Operating noise

Models: All GTE and GTI models which include as standard the assembly unit 9870 621 "Complete Fan" (see Liparts).

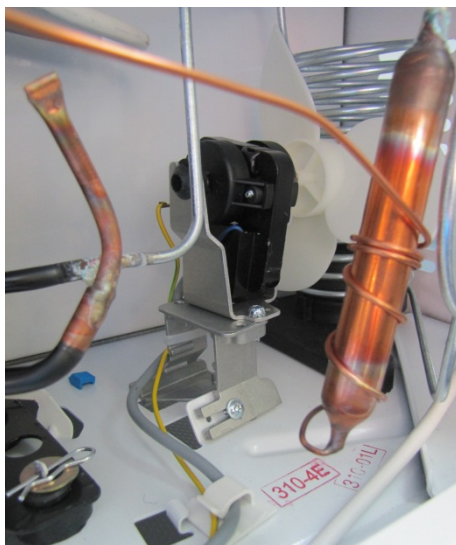
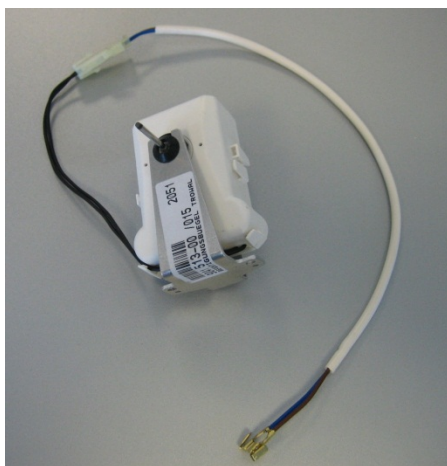
Fault profile: The fan in the compressor recess makes a perceptible operating noise.

To correct: The fan 9870 587 can be installed instead of the standard series fan.

The blades and the base of the original fan must be retained. The original fan's earth cable will no longer be required.
